CLIENT
University of Manchester

PROJECT
Manchester Museum Courtyard

Planning Comparison Drawing

DRAWING NAME
901 - Planning Comparison Drawing

Approved Scheme Changes

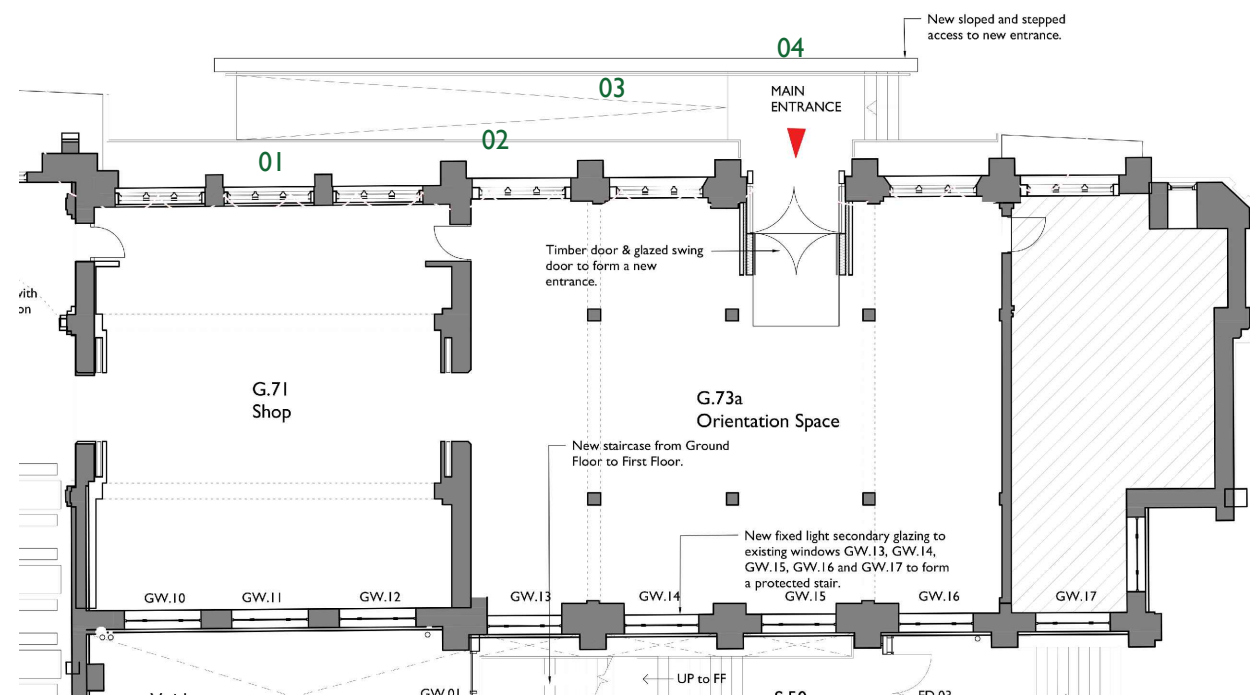
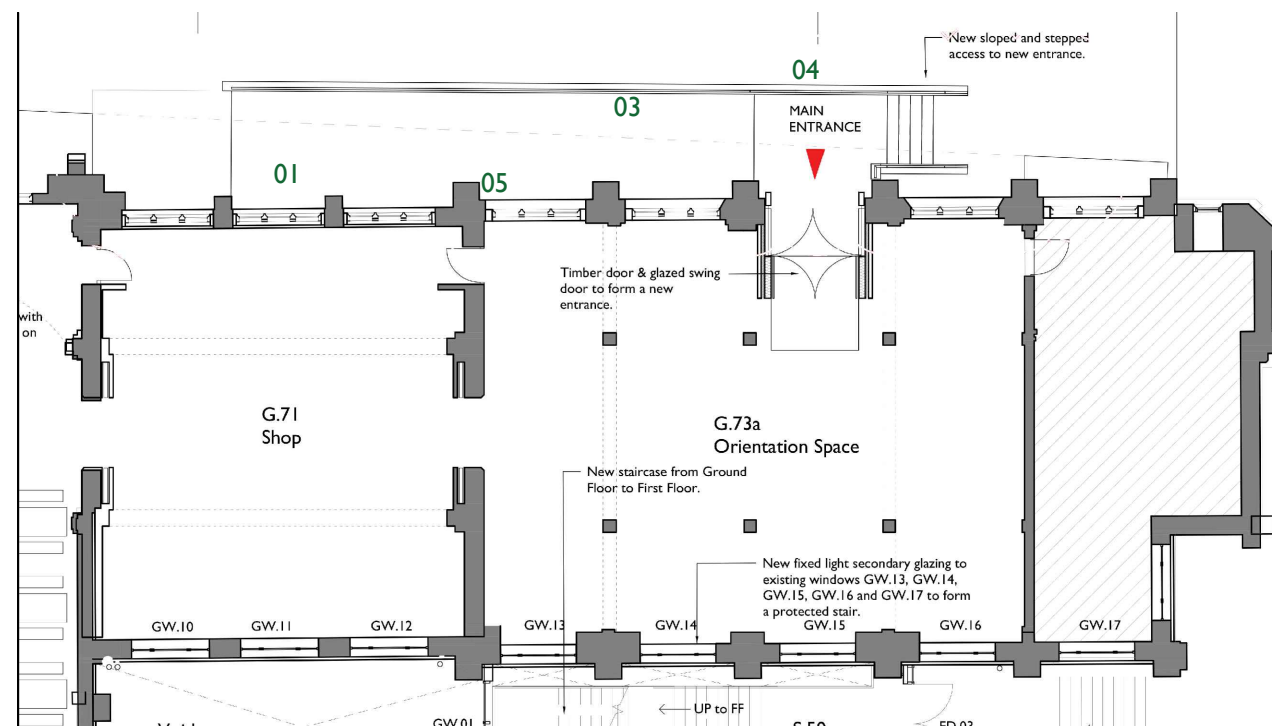
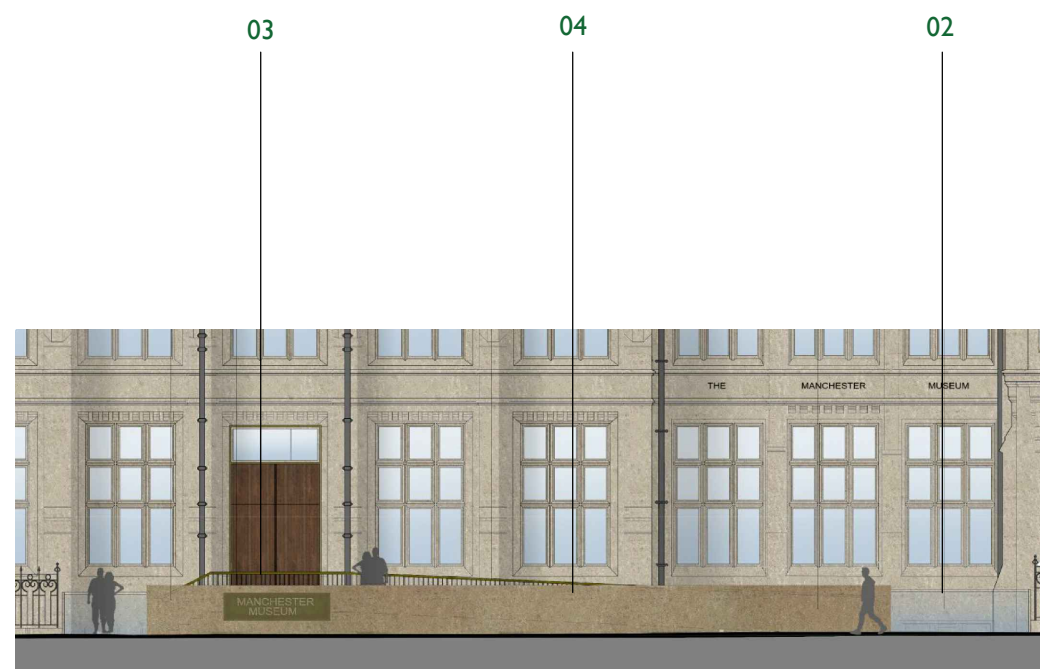
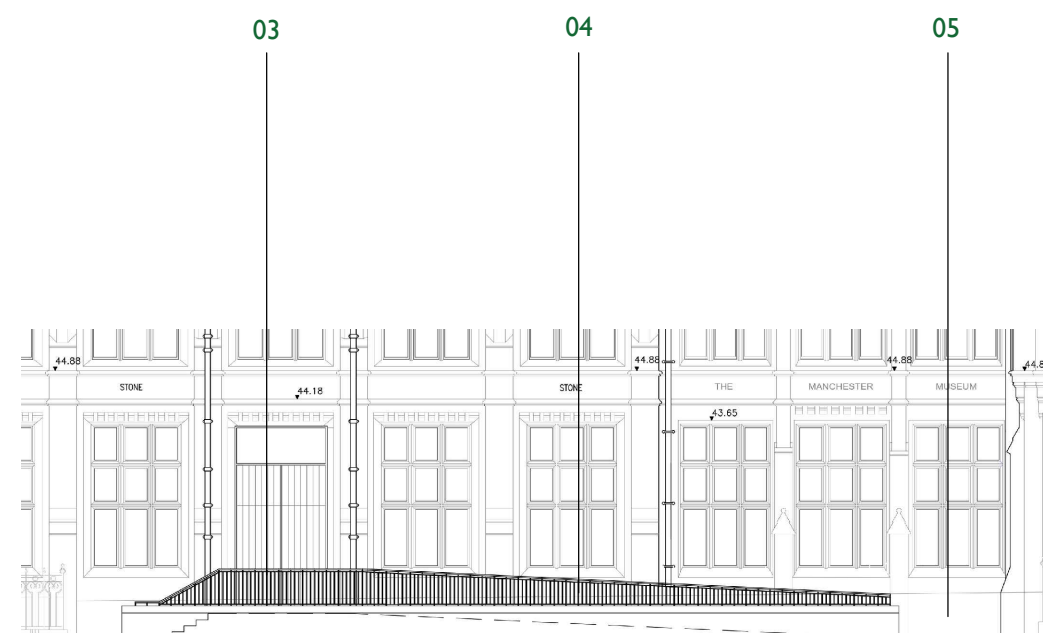
- 01 Section of moat which was left open is to be fully infilled by the new entrance slope/stair
- 02 glass guarding preventing people from falling into the moat is no longer required
- 03 the handrail/guarding which was floor mounted and protruded above the wall has been replaced by a railing mounted on top of the wall
- 04 the feature wall has reduced in height to improve visibility and the signage has been relocated (separate signage application submitted)
- 05 zinc skirt introduced around perimeter of existing building to conceal waterproof detail
